**FILE NO.:** HR 17-04: Historic Review for a new Public Works Operations facility in the McLoughlin Conservation District.

**REQUEST:** Proposal for construction of a new operations facility for the Oregon City Public Works Department in the McLoughlin Conservation District.

**HRB DECISION:** Approved With Conditions

Recommended Conditions of Approval  
Planning File HR 17-04

## Phase 1 Fencing Plan

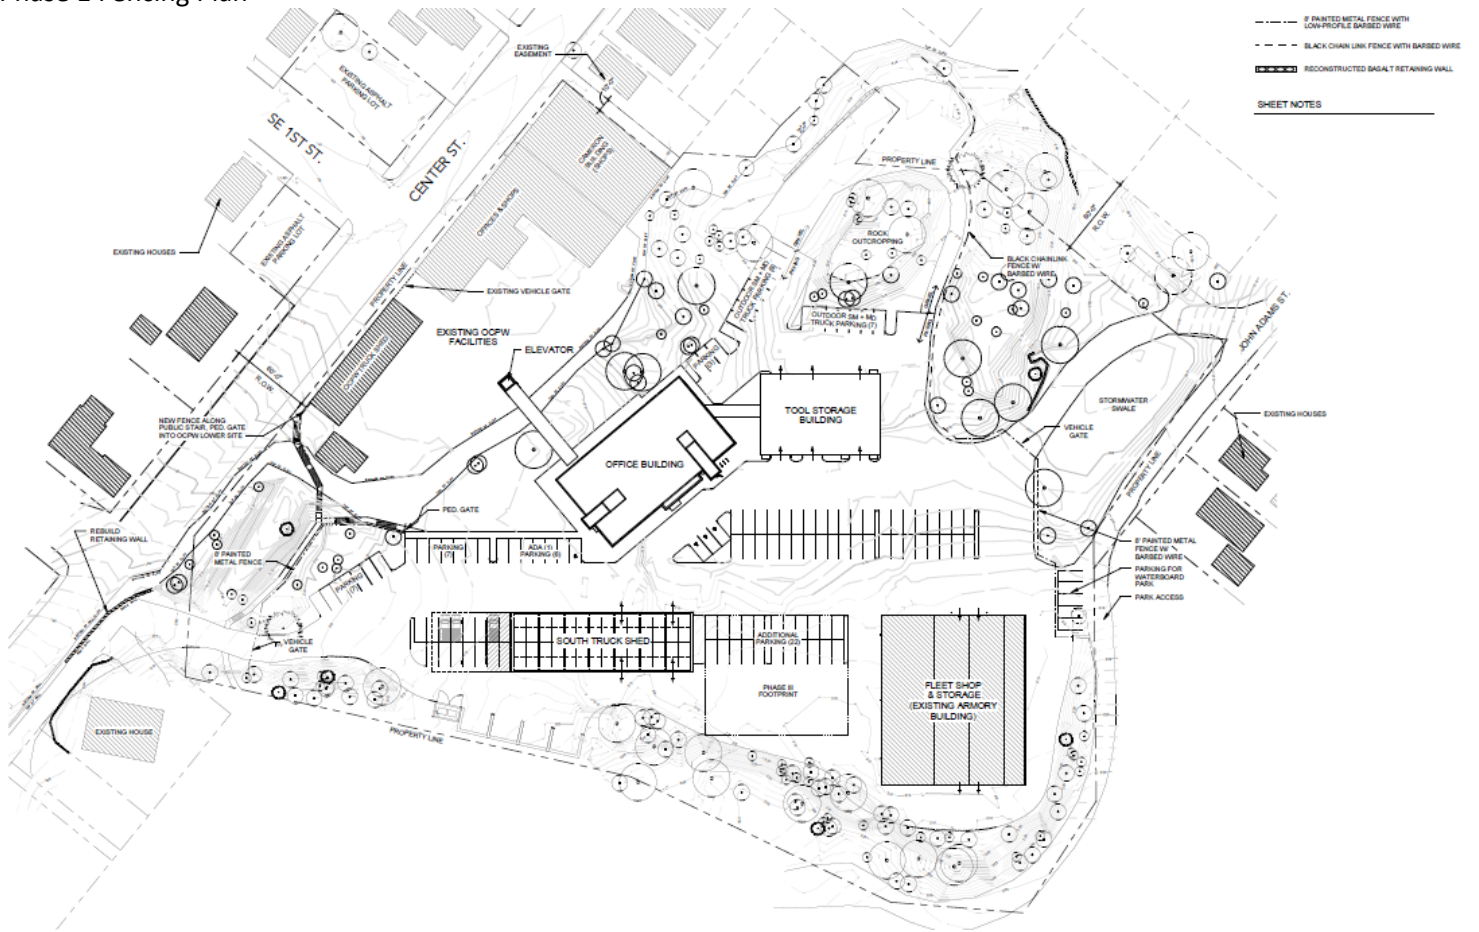
4. Fences may be placed along the side and rear perimeter of the site and shall not exceed six feet in height. Additionally, in an effort to maintain a contextual appropriateness, any proposed fences along the rear and side perimeter of the site shall not be composed of chain-link, vinyl, split rail, ornate wrought iron, stockade, plywood, or hard panel.

## Upper Lot Planting Plan

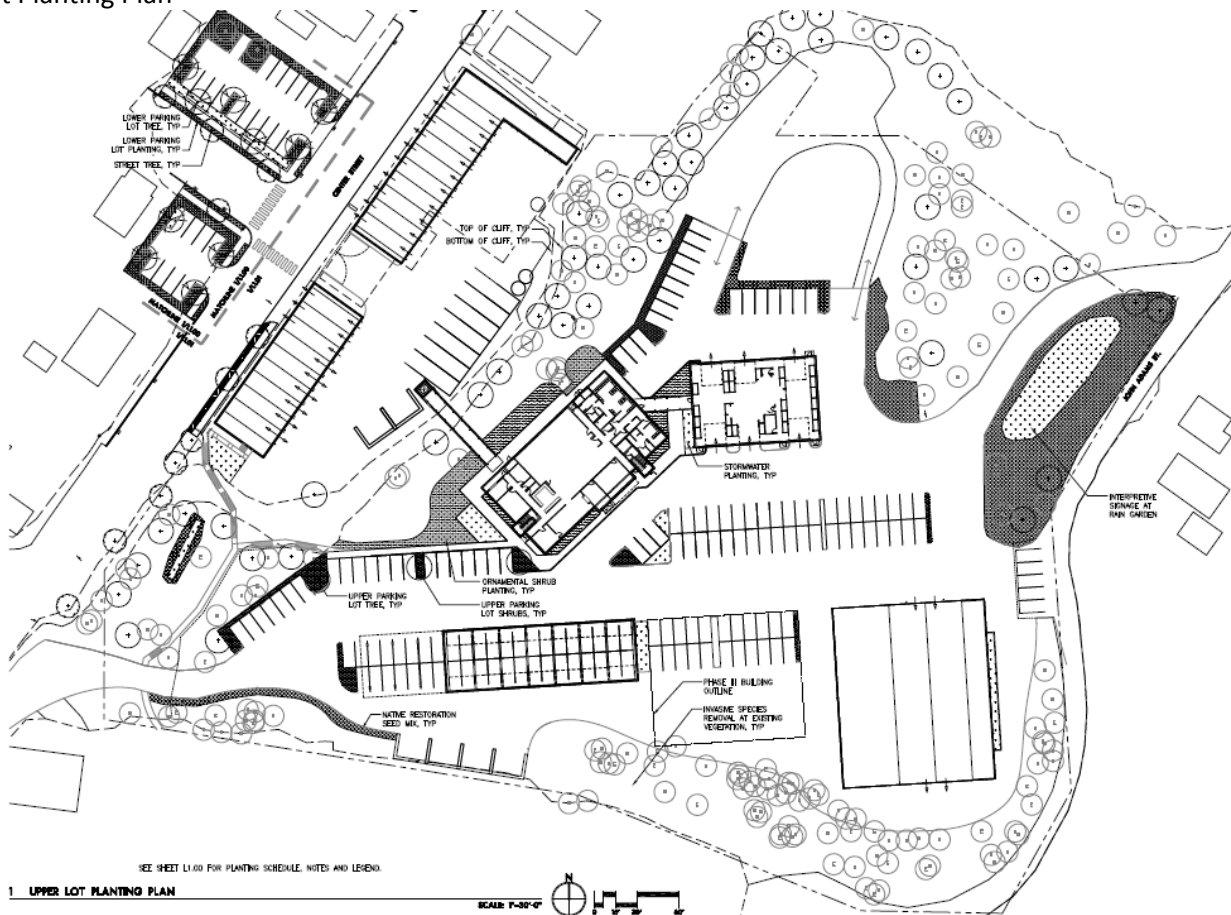
2. The applicant shall submit a landscaping plan with the following changes:
  - a. Documentation indicating that a minimum of 20% of the site is landscaped.(P)

- b. At least four (4) native trees, at least 15 feet in height when mature, and eight (8) shrubs (at least 3 ½ feet in height when mature, shall be planted along the northwest façade of the two story office building facing the South Center Street Right-of-Way.(P)

**Finding: Complies with Condition.** The applicant appears to have 20% of the lot landscaped as identified on sheet L100 and L101, but the calculation was not provided. Prior to issuance of a permit associated with the proposed development, the applicant shall submit documentation demonstrating that a minimum of 20% of the site is landscaped. **HRB has determined that it is possible, likely and reasonable that the applicant can meet this standard through the Conditions of Approval.**

Elevator

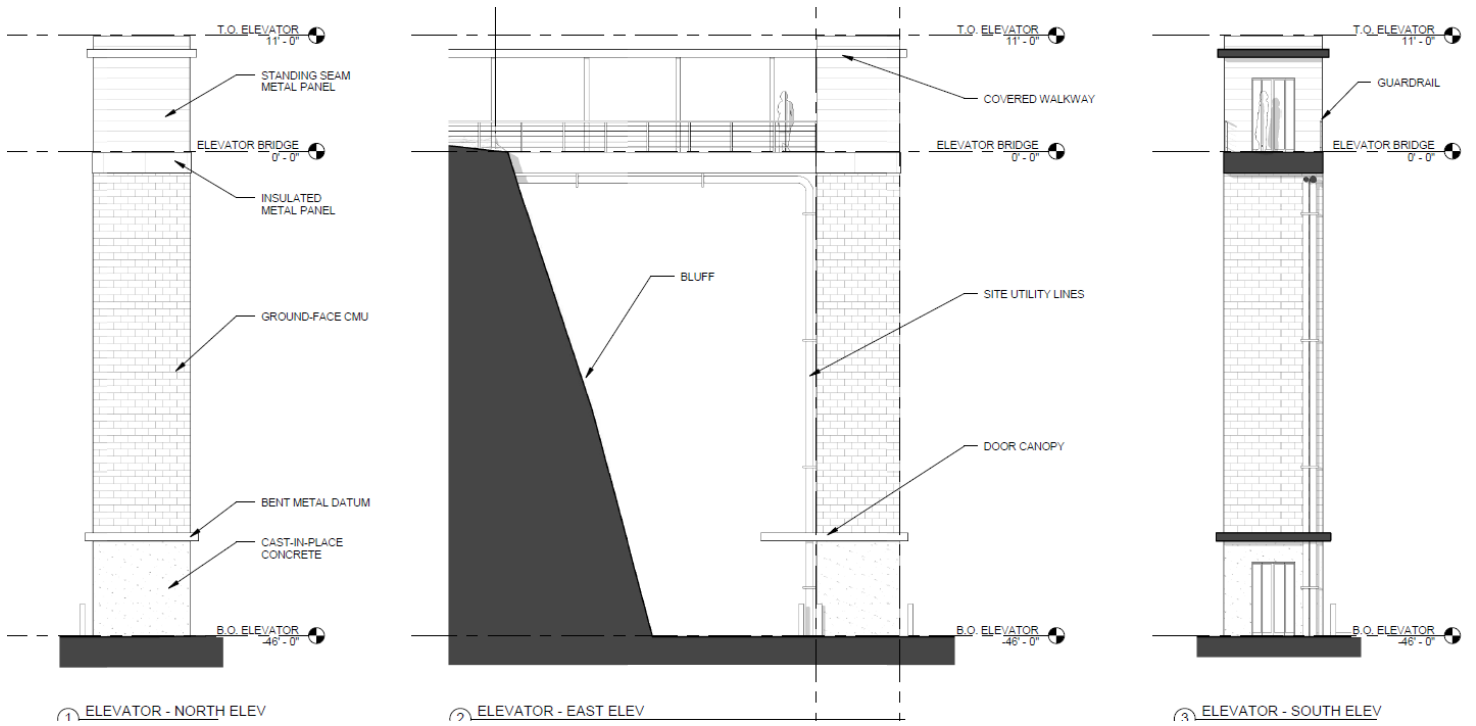
6. The materials on the elevator shall be comprised of the same materials proposed to be used on the building. Those materials include stone and metal exterior façade pieces designed in neutral and soft earth tones colors.
